**ADDENDUM
NO. 3**

**BOONE GROVE HIGH SCHOOL
RENOVATION AND RELATED WORK
Valparaiso, IN 46341**

ADDENDUM THREE

Addendum Three (AD.03) to the drawings and specifications prepared by Gibraltar Design for **Boone Grove HS Renovation and Related Work** for Porter Township School Corporation, Valparaiso, Indiana.

4
E-204
UNIT "F" ELECTRICAL MEZZANINE FLOOR PLAN
1/8" = 1'-0"

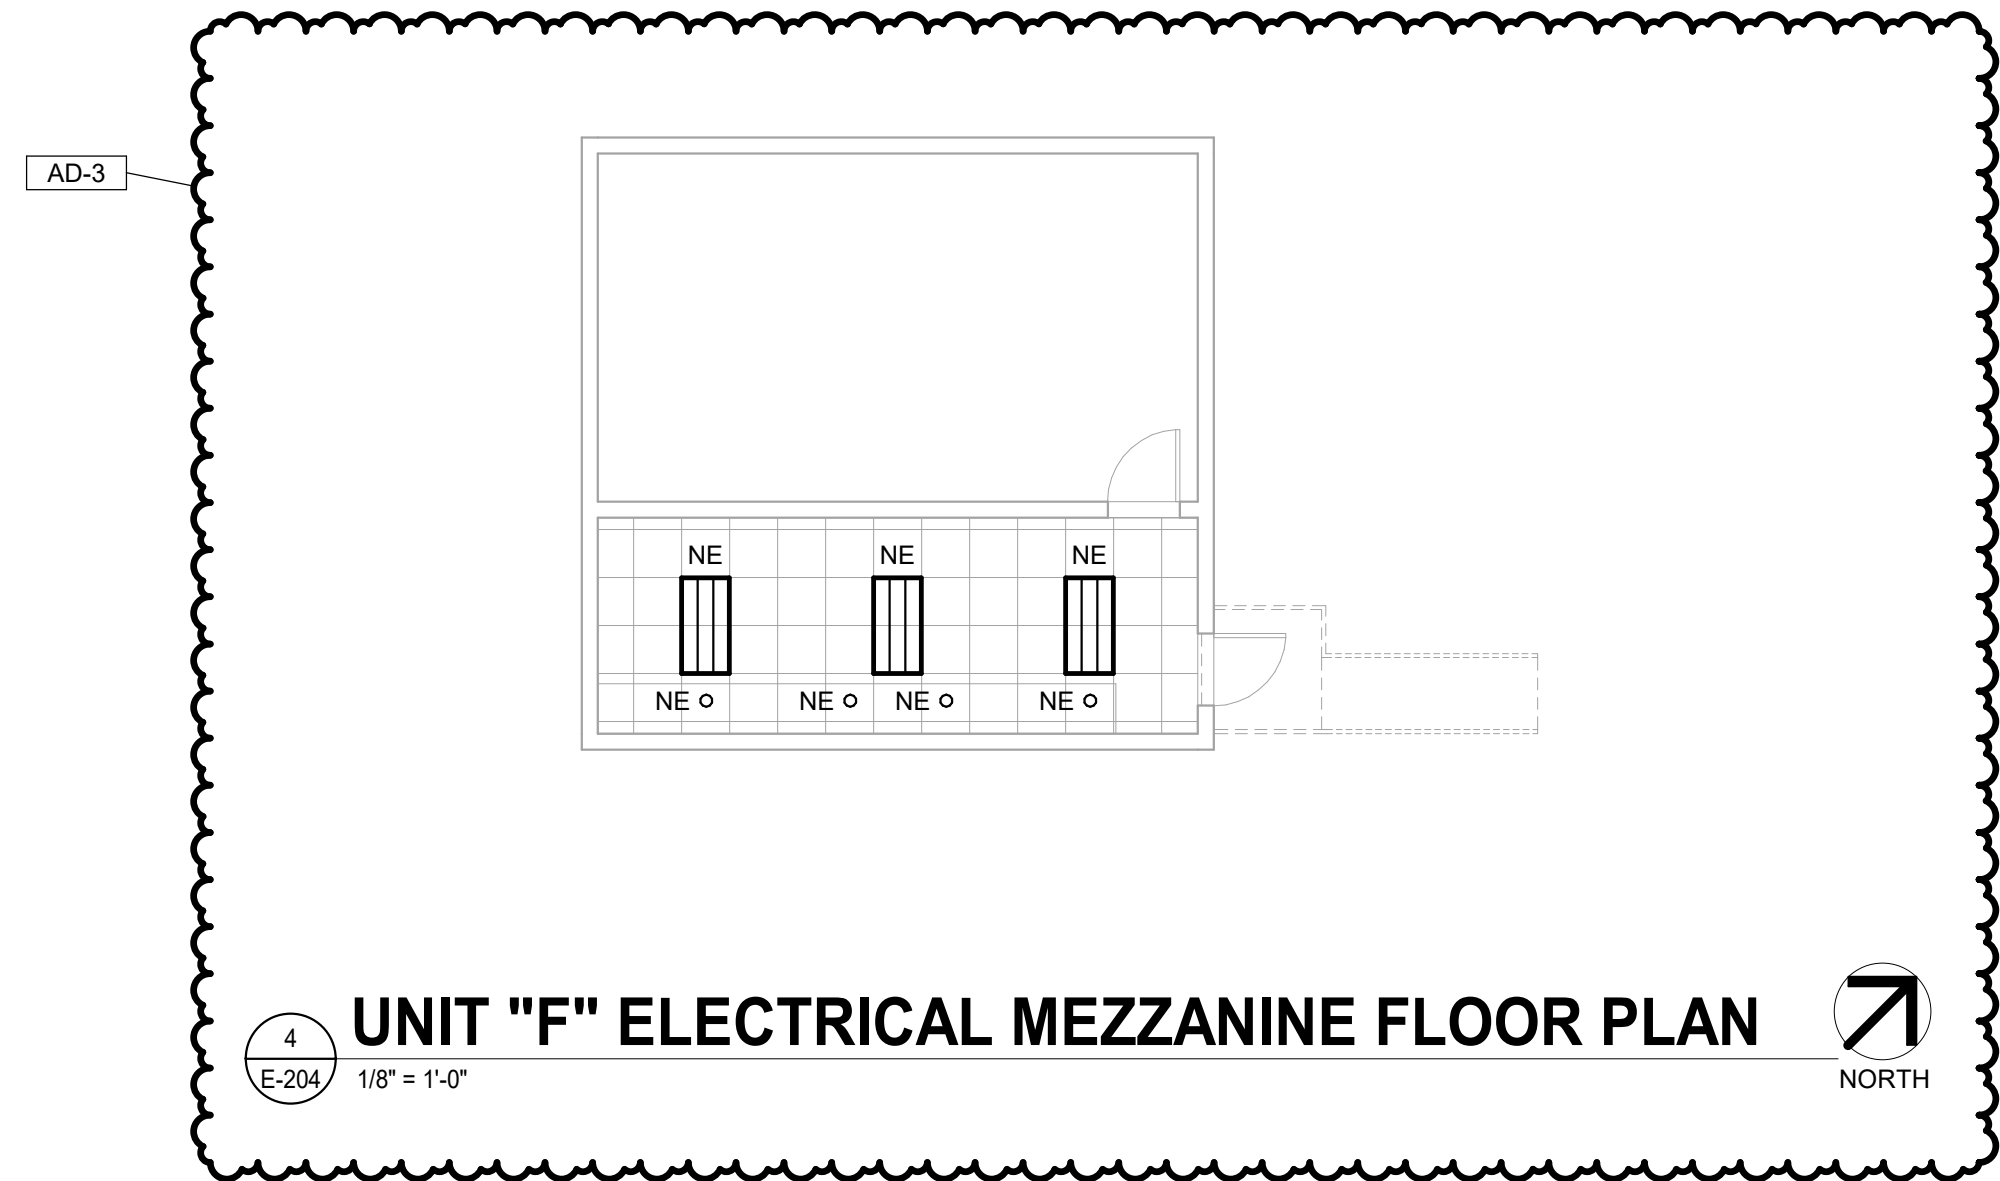
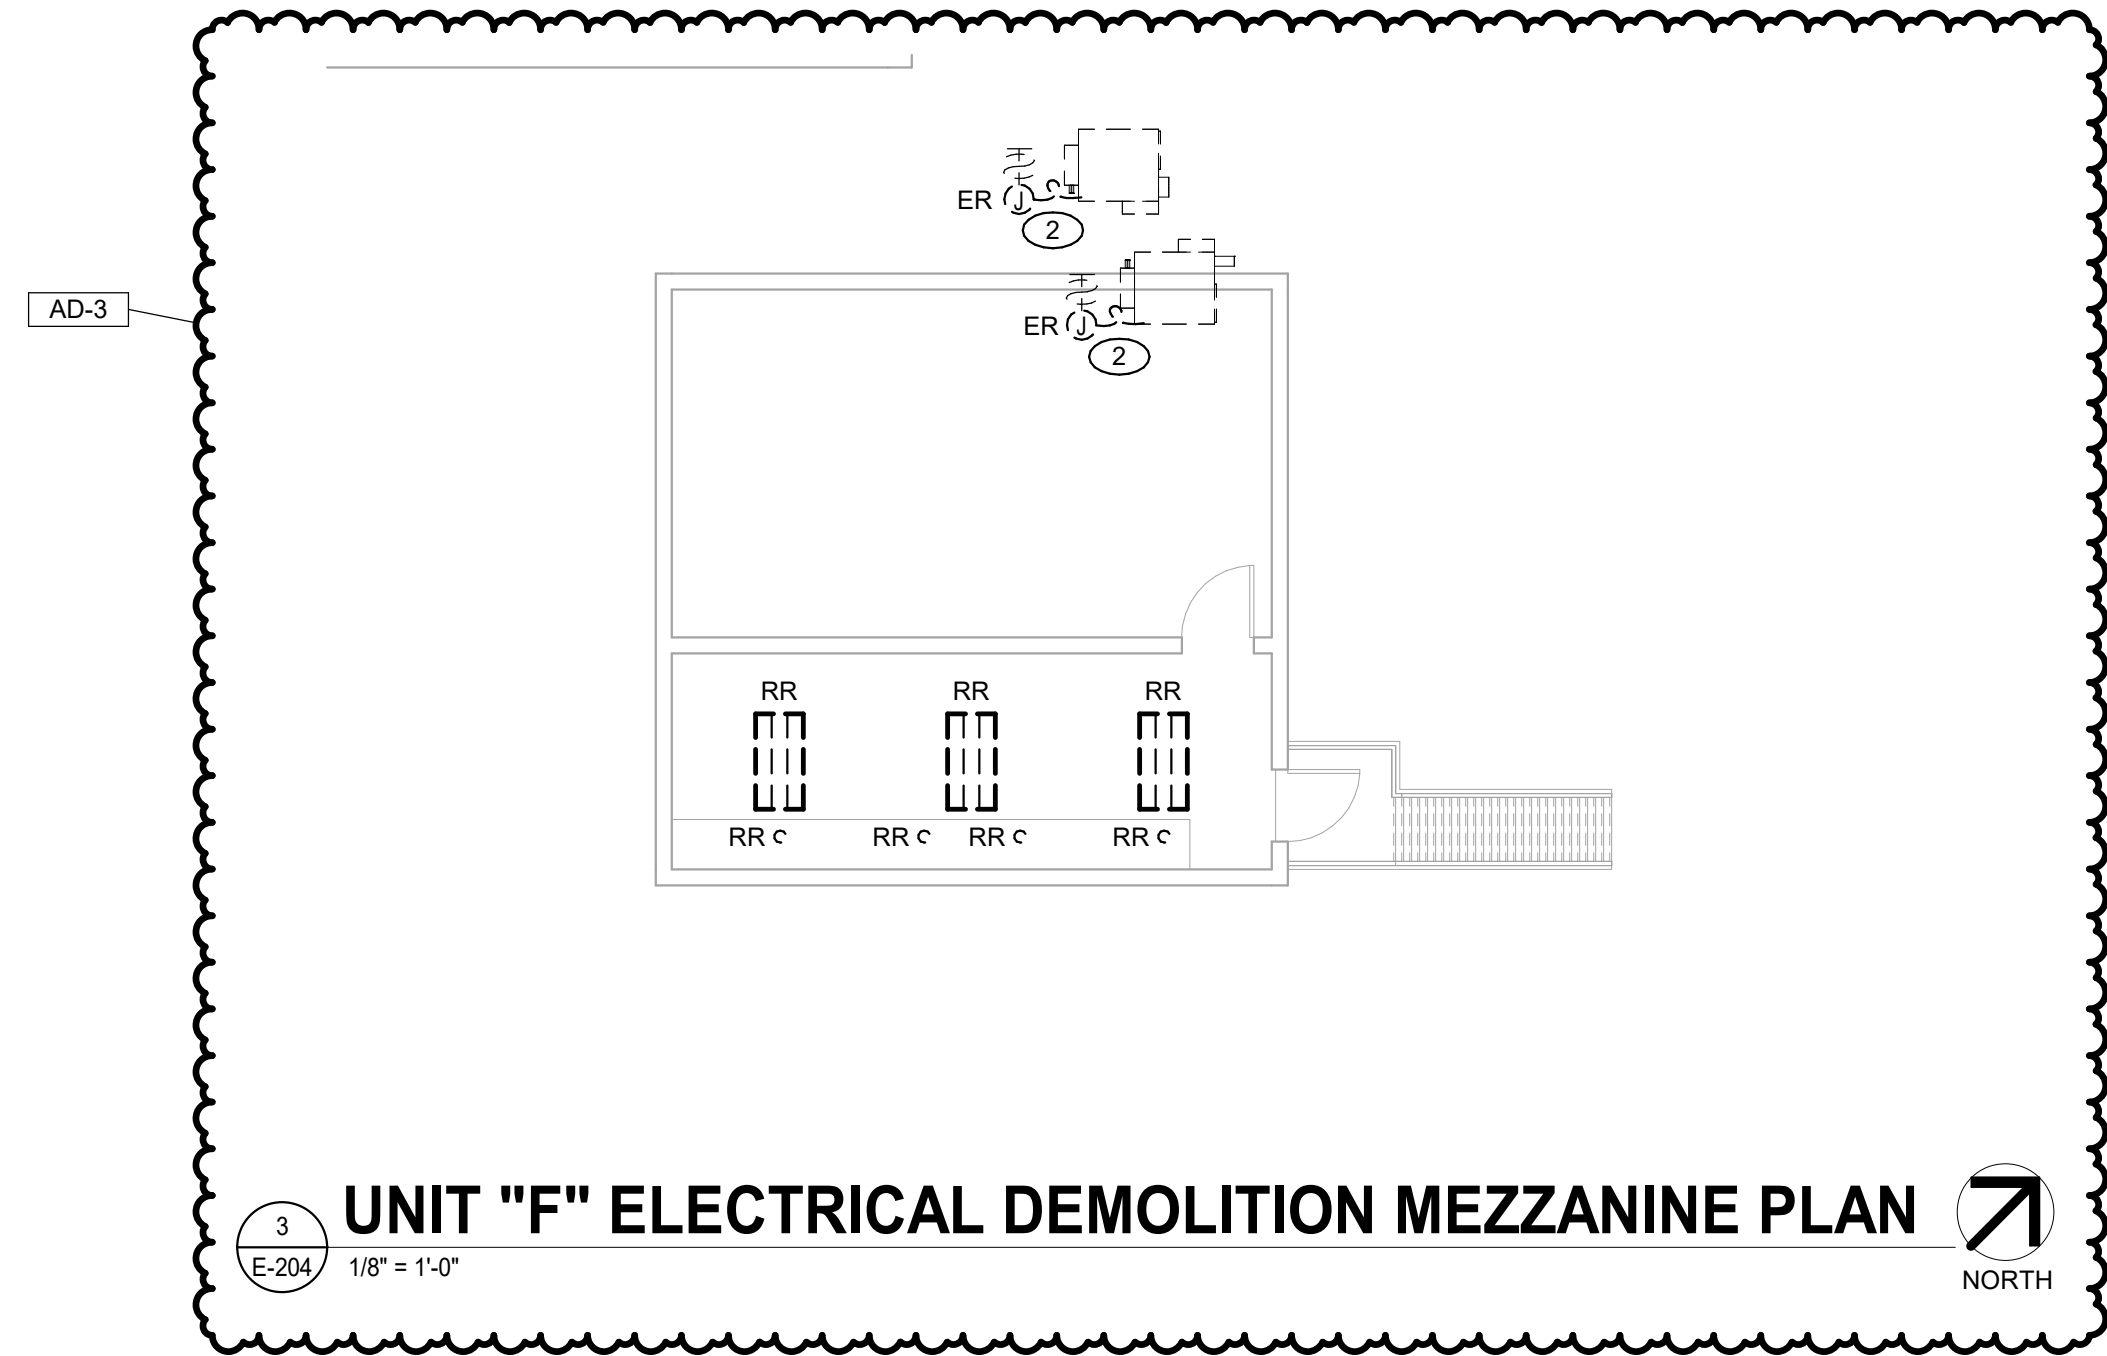
- A. Refer to revised, full-size drawing, included in this Addendum, for revisions.
 1. Added demolition and new construction views for Unit F Mezzanine.
 2. Added light fixtures to be removed and relocated in Unit F Demolition Mezzanine Plan.
 3. Added new locations for relocated light fixtures in Unit F Mezzanine Floor Plan.
